SUNDRY NOTICES AND REPORTS ON WELLS

CARBON VALLEY 25 FEDERAL COM

**Carbon Valley 25 Fed Com 8H
30-015-39851
Murchison Oil & Gas, Inc.
March 16, 2012
Conditions of Approval**

EXHIBIT G-1

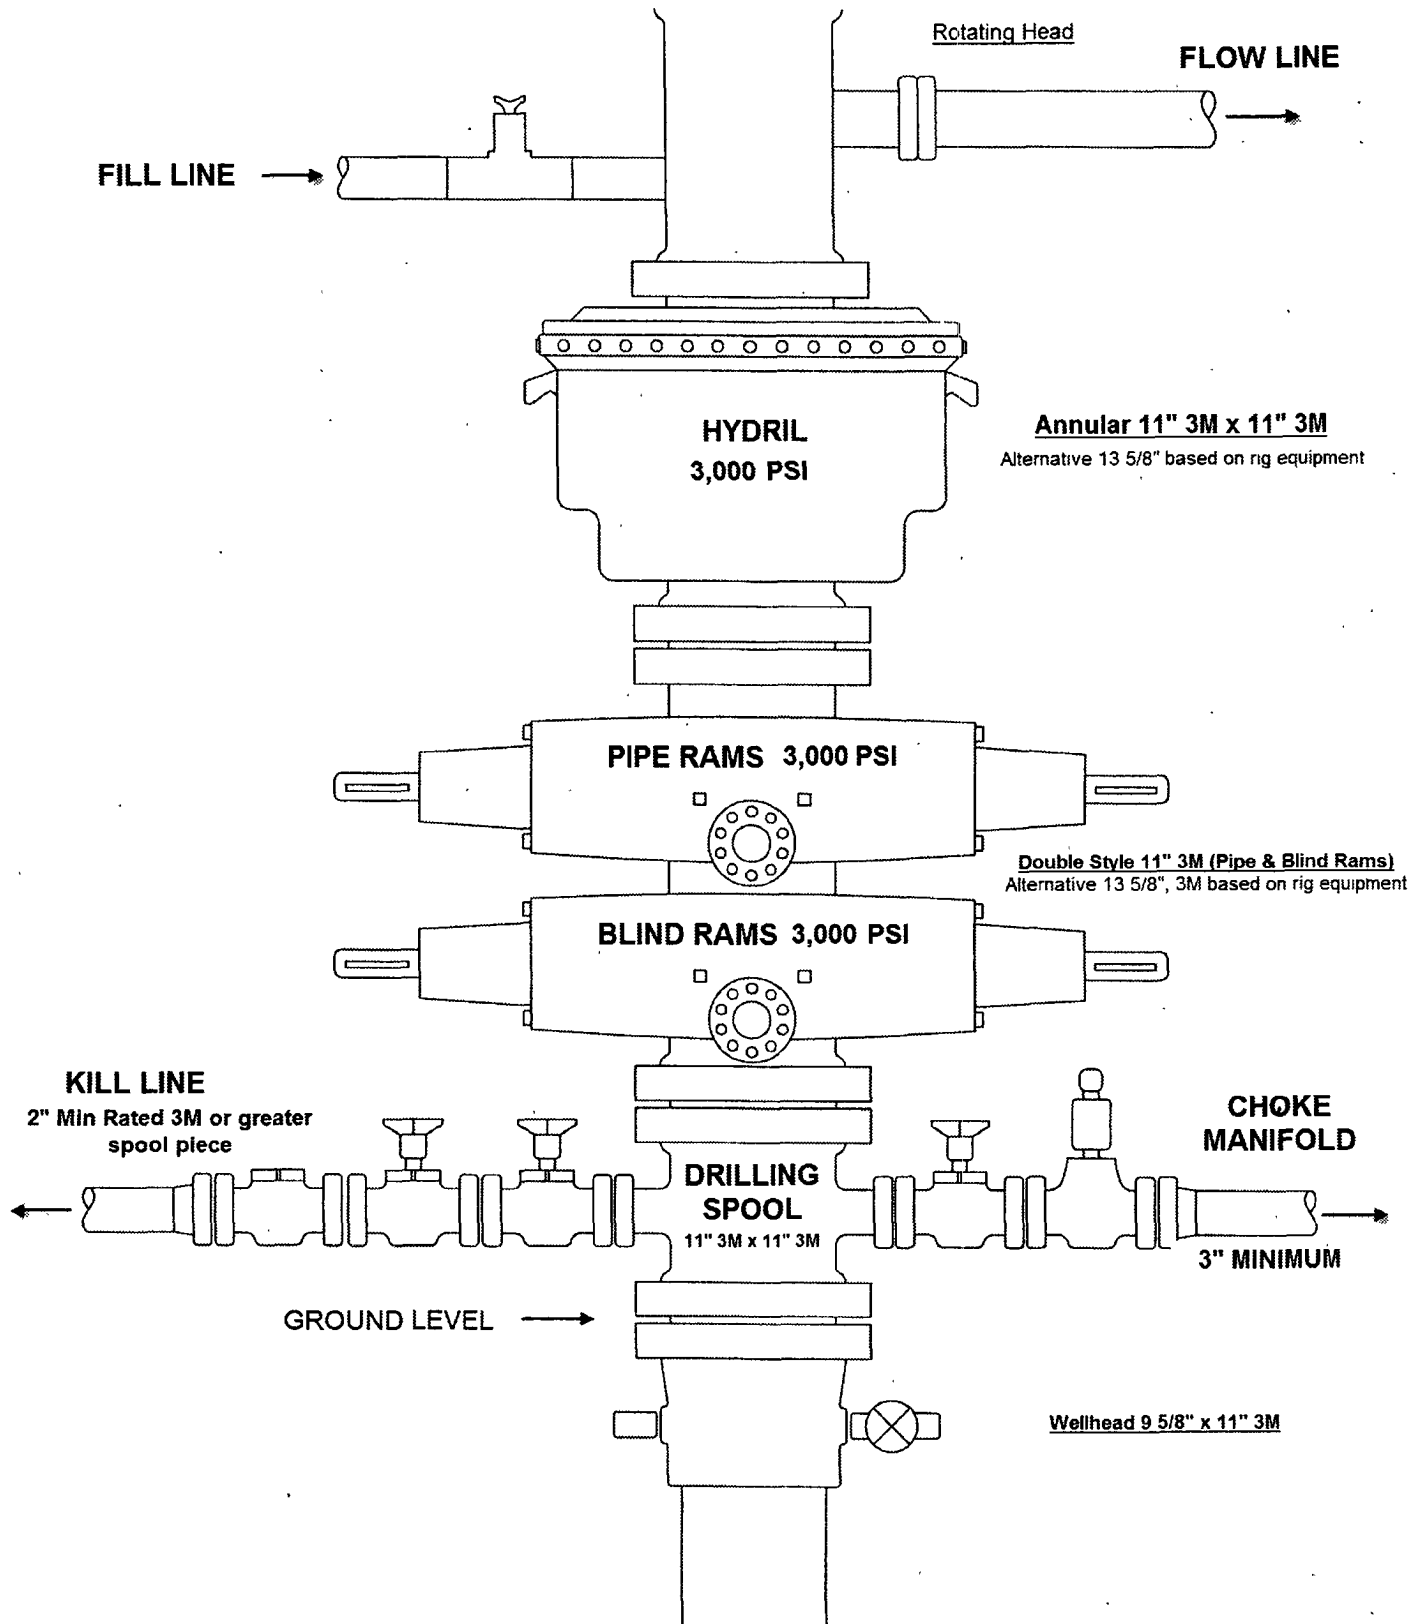
We respectfully request the drilling rig's BOP pressure requirement be reduced from 5000 psi to 3000 psi. We believe the 3000 psi rating will be adequate for our maximum expected bottom hole pressure of 2800 psi. We simultaneously request the elimination of any associated mud equivalency test requirement.

- 1. Approved for 3M system and the elimination of formation integrity tests.**
- 2. Reviewed with operator on 3/16/2012 – the approved directional plan did not have a tangent section. Therefore, this item is considered non-applicable.**
- 3. Operator is approved to stimulate and produce entire length. Operator should be aware that the stimulation in the sections already treated in the 5H could result into a fracture into that well bore.**
- 4. Operator approved for 7" casing setting depth range of 6350' – 6611' MD as long as the casing is set a minimum of 50' below the top of the Wolfcamp.**
